Re: ISCR Workplan and Corrective Action Workplan
Former Holley Automotive/Coltec Industries Facility, Water Valley, MS

On behalf of EnPro Industries, Inc. (EnPro), First Environment, Inc. (First Environment) is submitting these responses to your February 21, 2018 email on behalf of the Mississippi Department of Environmental Quality (MDEQ) providing comments on the ISCR Workplan and Corrective Action Workplan (CAWP) regarding the Former Holley Automotive/Coltec Industries Facility (the "Plant") and known downgradient plume area (collectively referred to as the "Site").

MDEQ Comments regarding the ISCR Workplan (CAWP Addendum No. 1)

FORMER HOLLEY AUTOMOTIVE/COLTEC INDUSTRIES FACILITY
600 Highway 32E, Water Valley, MS
FIGURE 2
MONITORING WELL LOCATIONS

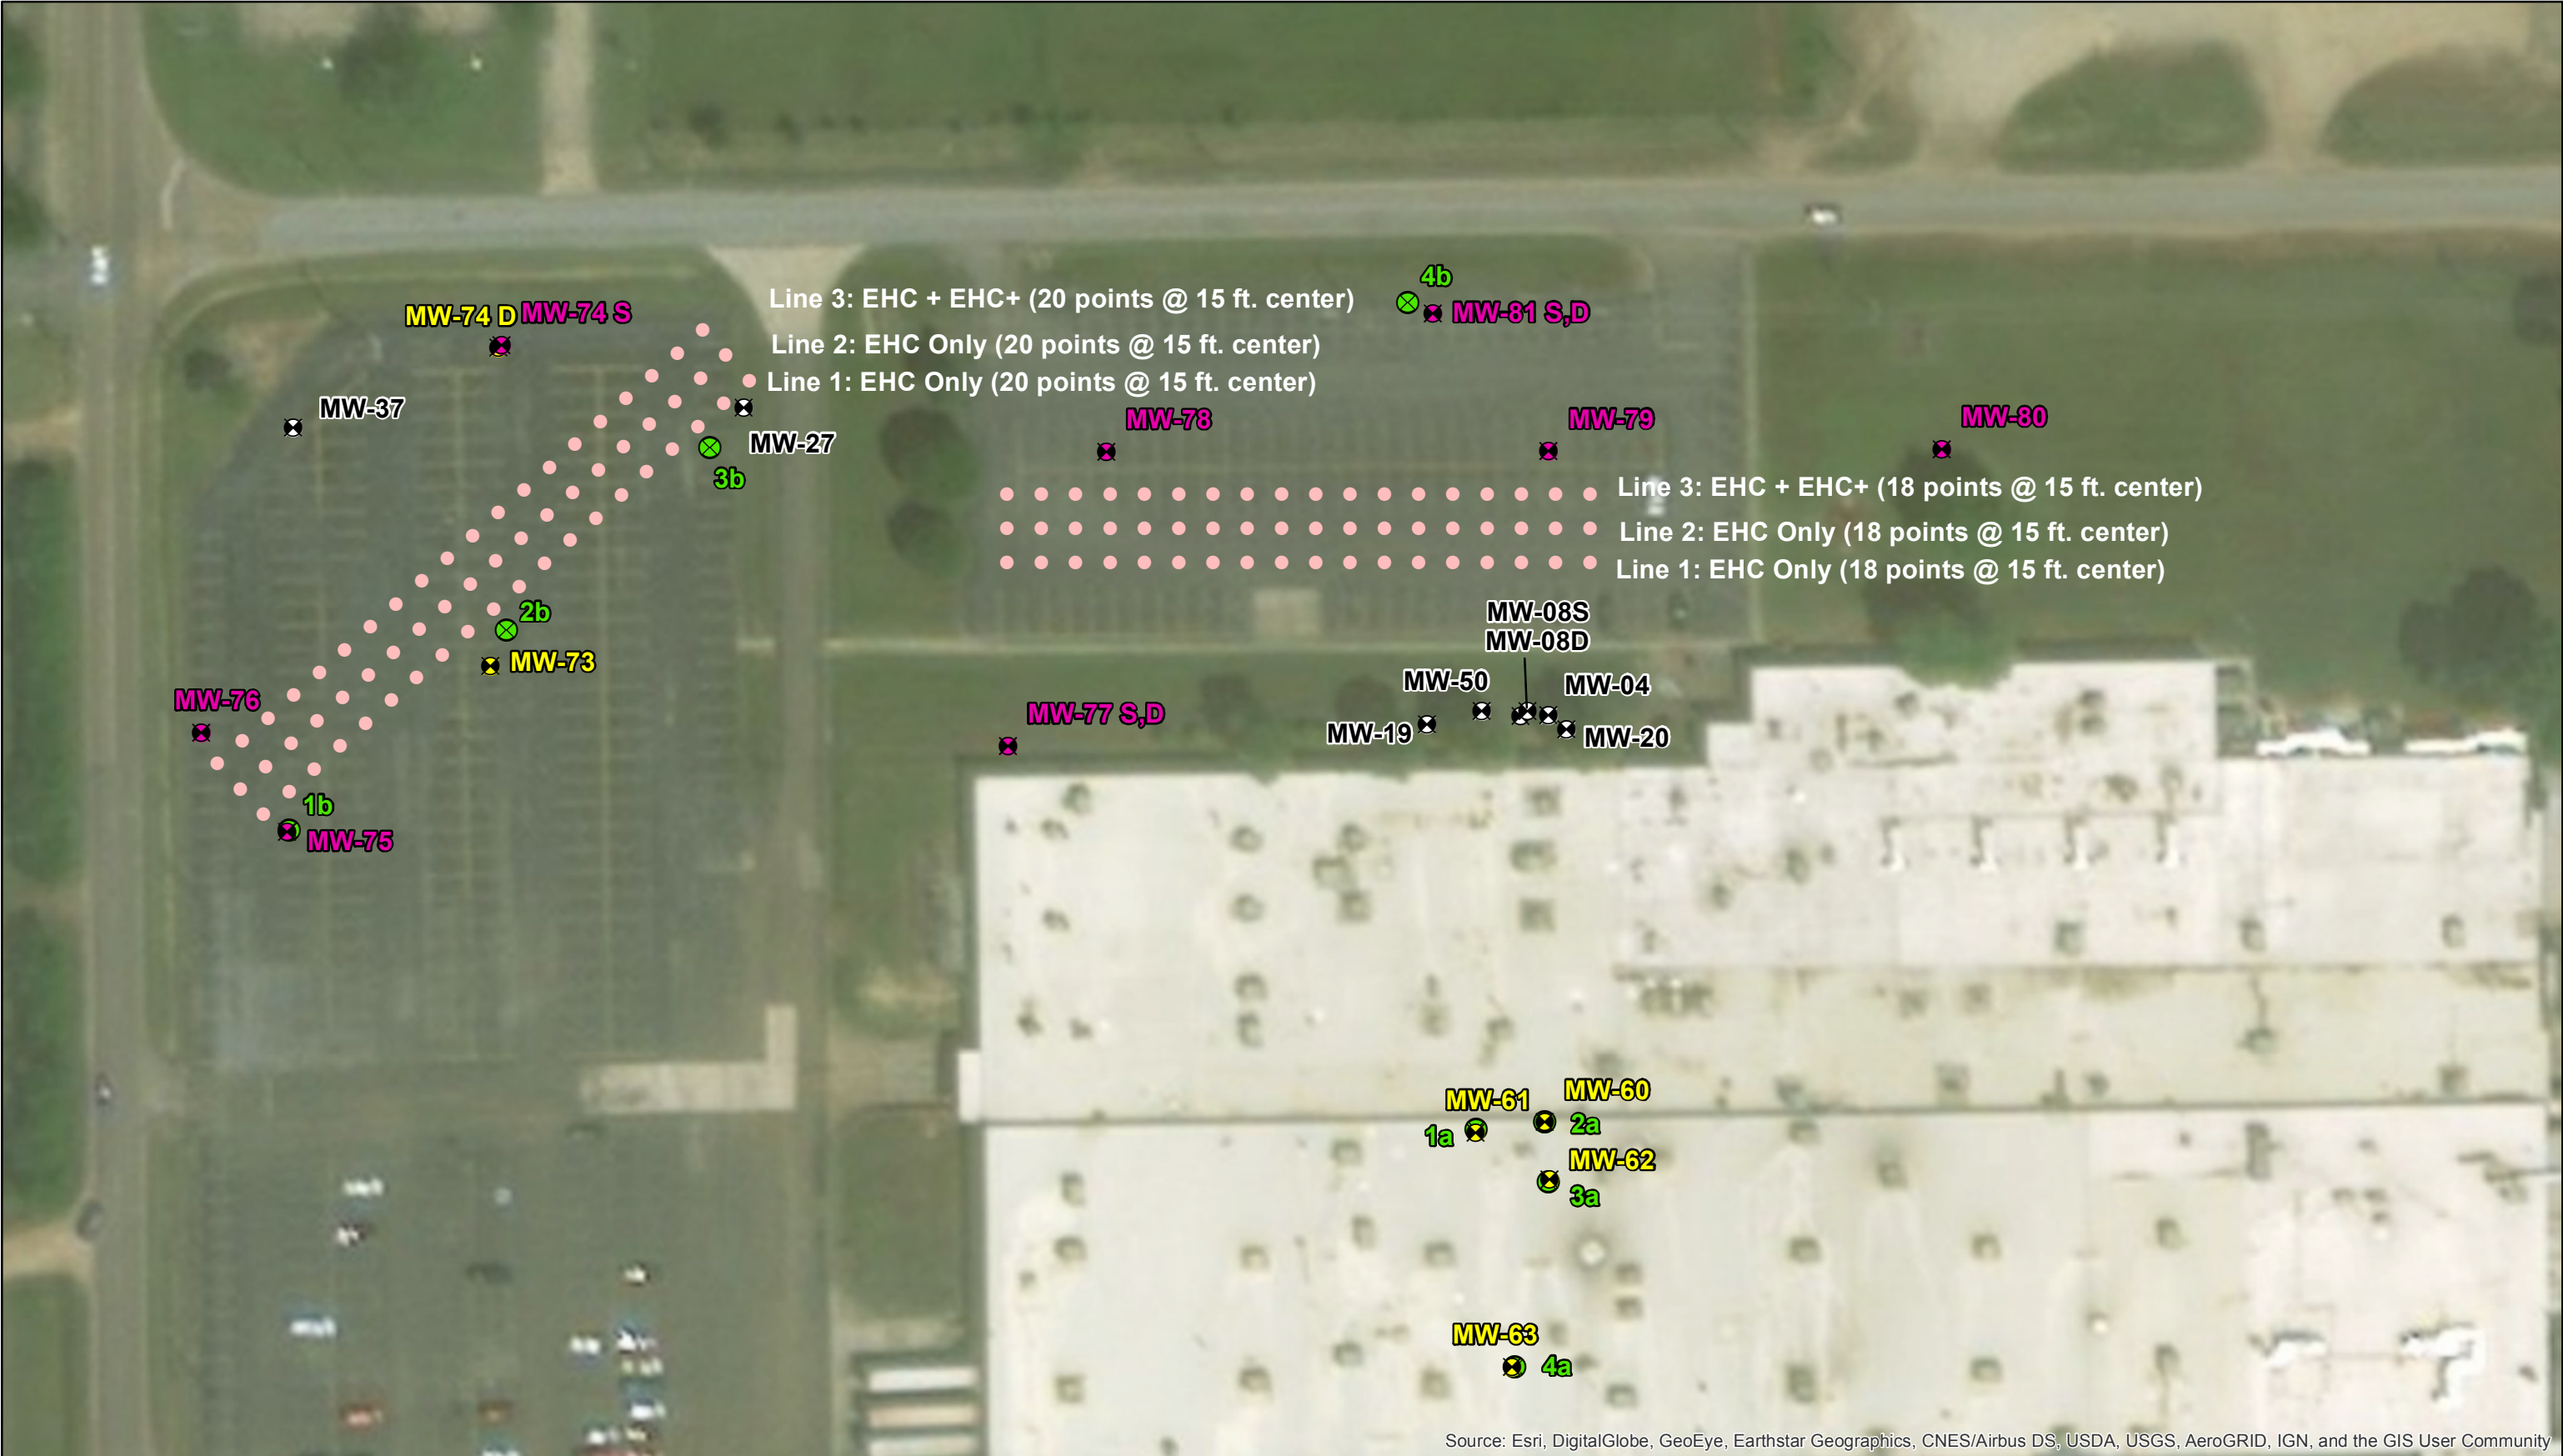
7. Section 7.1 of this work plan selects high vacuum dual-phase extraction (HVDPE) as the chosen remedial option for the former TCE degreasers and TCE supply structures. The pilot test discussion and all supporting design documents should be included within this corrective actions plan.

During the pilot test, First Environment will utilize newly installed MW-70 as an extraction well. Figure 2 depicts the locations of the newly installed monitoring wells. First Environment selected this well based on the February 2018 sampling results, which revealed a TCE concentration of 21,200 µg/L. Furthermore, MW-70 is the closest well to the former AST area and is located directly adjacent to the Plant building. First Environment will utilize indoor wells MW-60, MW-62, and MW-63 and outdoor wells MW-65, MW-66, MW-67, MW-69, MW-71, MW-72, and MW-36 as observation wells.

FIGURE 1
PROPOSED MONITORING WELL LOCATIONS

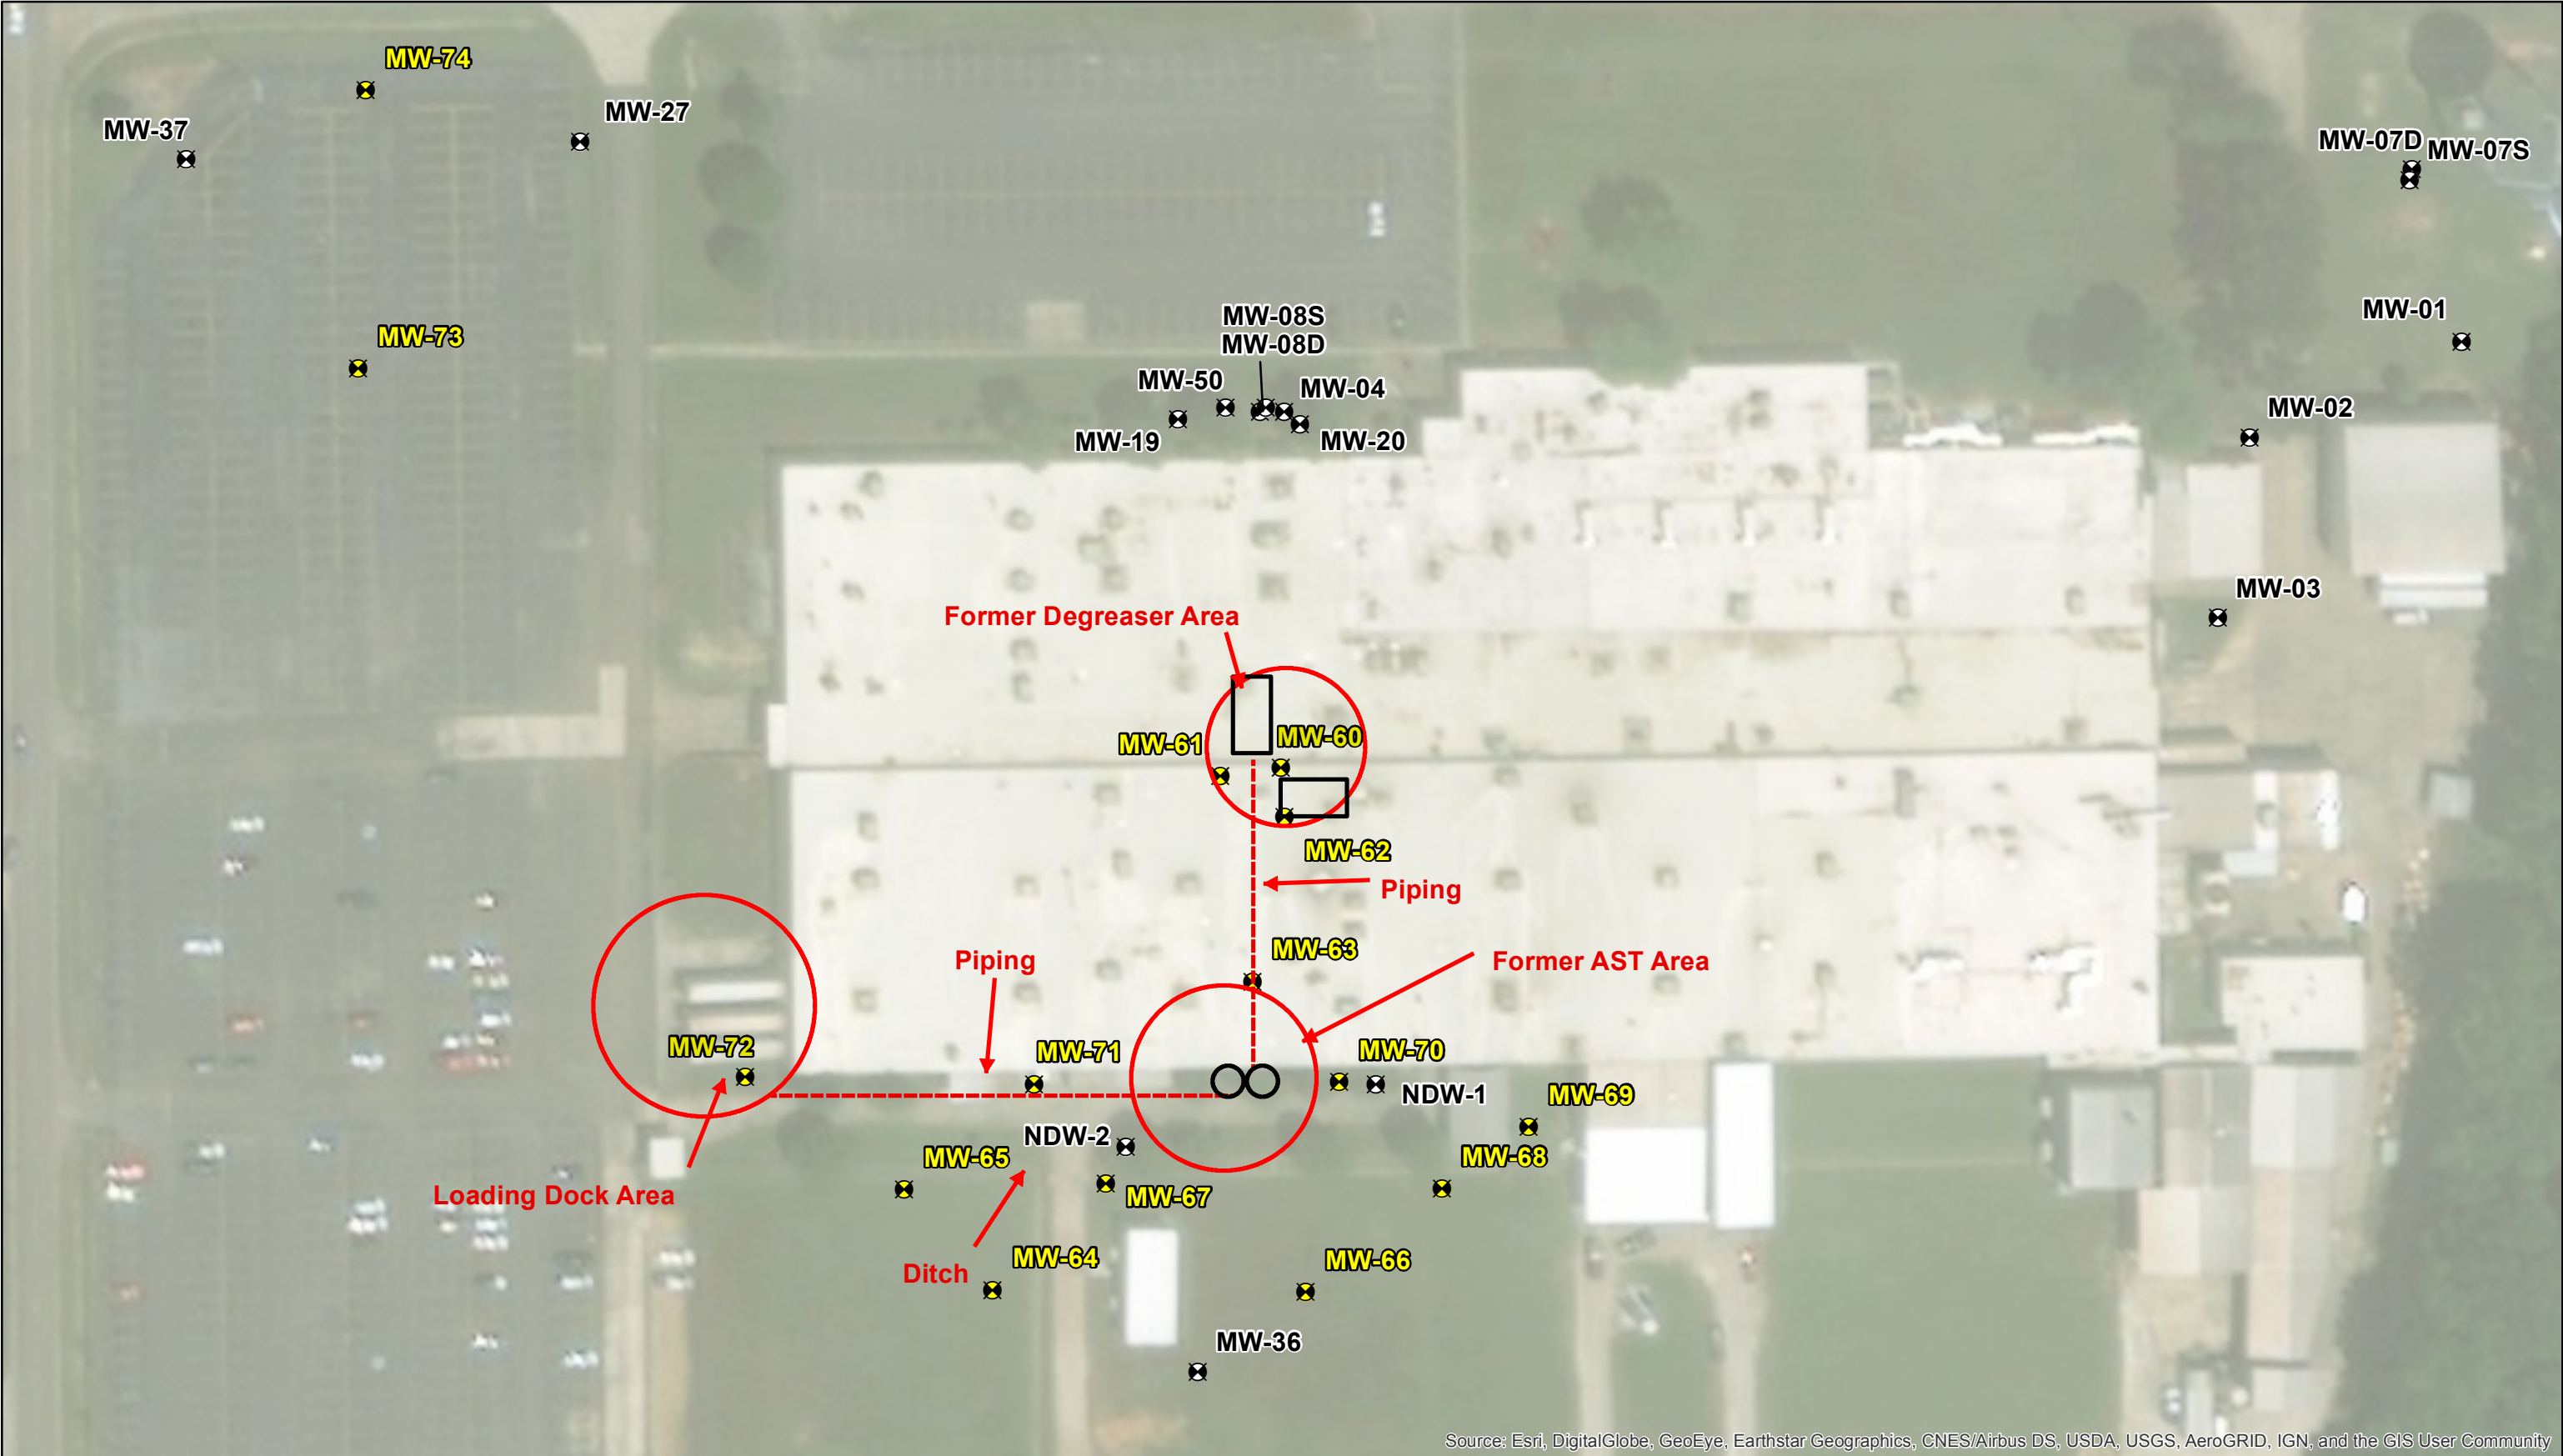
1. MDEQ does not believe that the currently proposed ISCR curtain construction length will completely intersect the migrating COC plume meeting the objectives as outlined in the CAP; expanding the curtain to the east would provide better coverage. Please respond.

2. The Workplan proposes the installation of two monitoring wells (PMW-1 and PMW-2) utilizing 25-foot screens in order to monitor the proposed reactive curtain's effectiveness. Being that these proposed monitoring wells are being installed as performance monitoring wells, MDEQ would typically require the use of clustered wells (one well screened across the water table and one well screened at the confining clay) at each location utilizing a 10-foot well screen, please respond.

3. MDEQ suggests additional wells need to be installed in the area of the ISCR curtain to aide in the evaluation of the curtain's performance.

There is an unoccupied field directly to the north of the Plant building, east of the currently proposed ISCR curtain. Counsel for EnPro is working to place institutional controls on the property. In addition to this, EnPro proposes to expand the ISCR curtain to the east at the tentative location, subject to field verification of utilities, as shown on Figure 1 attached, and described in more detail in response to Comments 4 and 5 below. Counsel and First Environment will work with BorgWarner on the logistics. The ISCR work may need to be done in phases to avoid disruption of the BorgWarner Plant operations.

With respect to the proposed expansion of the curtain to the east, First Environment proposes to install seven (7) monitoring wells as depicted on Figure 1. First Environment proposes to screen MW-77S, MW-78, MW-79, MW-80, and MW-81S at 25 ft. to 40 ft. bgs; and MW-77D and MW-81D at 40 to 50 ft. bgs.

There are currently two wells located immediately upgradient of the proposed ISCR curtain (MW-27 and MW-73) and two wells located immediately downgradient (MW-37 and MW-74). With the addition of a couplet well at the location of MW-74, and the installation of two (2) additional monitoring wells, these seven (7) monitoring wells in the northwest parking lot will enable First Environment to evaluate the initial performance of the northwest parking lot ISCR curtain.

Additionally, as discussed in response to Comments 1 and 2, First Environment has evaluated the eastward expansion of the ISCR curtain to the north parking lot of the Plant. Figure 1 depicts the proposed additional injection points. A January 2018 geophysical markout identified a sewer line running from west to east at the uppermost boundary of the north parking lot. The grass area between the northwest and north parking lots contains numerous utilities. Additionally, the entrance on the north side of the Plant is a major trucking route entrance. Based on these conditions, First Environment moved the proposed curtain closer to the Plant building. The depicted locations will need to be verified in the field by a subsequent geophysical survey, which will be conducted prior to the installation of the curtain.
